# ADDENDUM 001

<b>project</b>	Kearns Oquirrh PFC Improvements	<b>project no</b>	18745.00
<b>date</b>	2019-02-04	<b>no. pages</b>	
<b>owner</b>	Kearns Improvement District		
<b>contractor</b>			
<b>bid date</b>	2019-02-12	<b>bid time</b>	3:00 pm MST

**Electrical Addendum No. 1**

# ADDENDUM

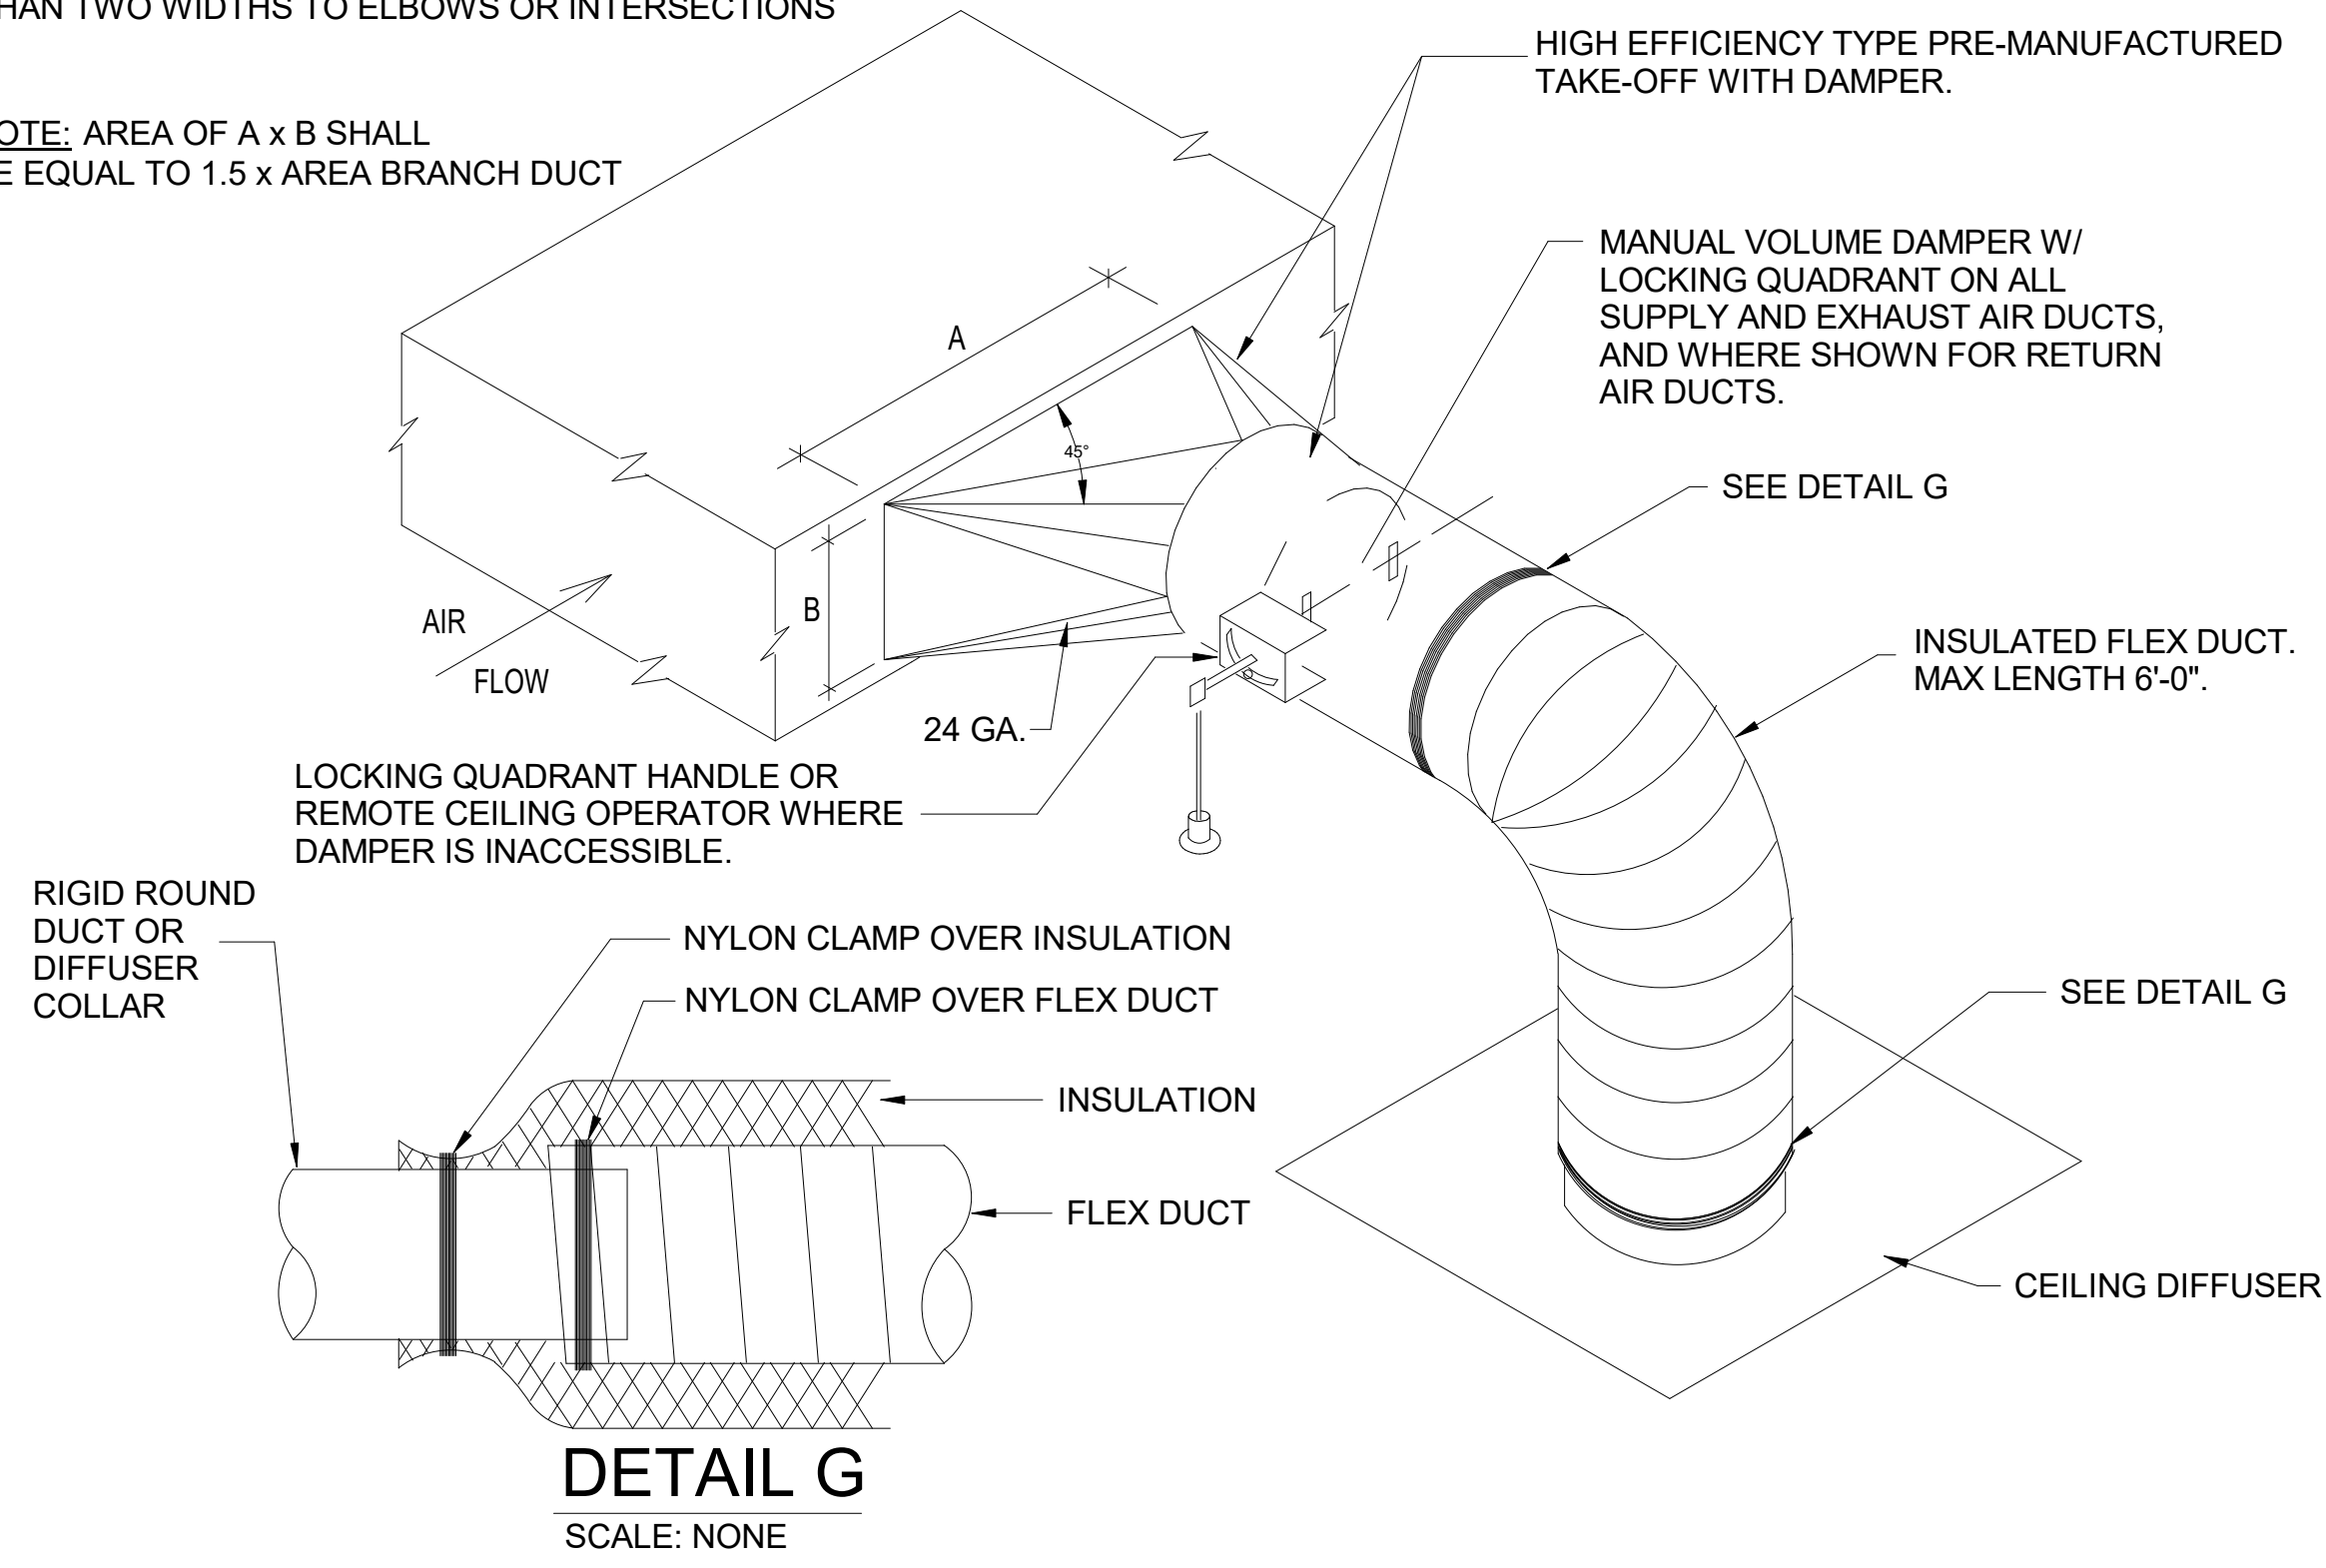
- Item VI-1.** ME101: Duct layout has been redesigned to coordinate with structural. Rooftop unit location shifted slightly and was rotated 90°. Relocated supply diffusers and return grille. Exhaust duct up through roof location shifted slightly.
- Item VI-1.** ME601: Exhaust fan model number change, electrical demands increased slightly. R-1 return grille changed to 24"x12".
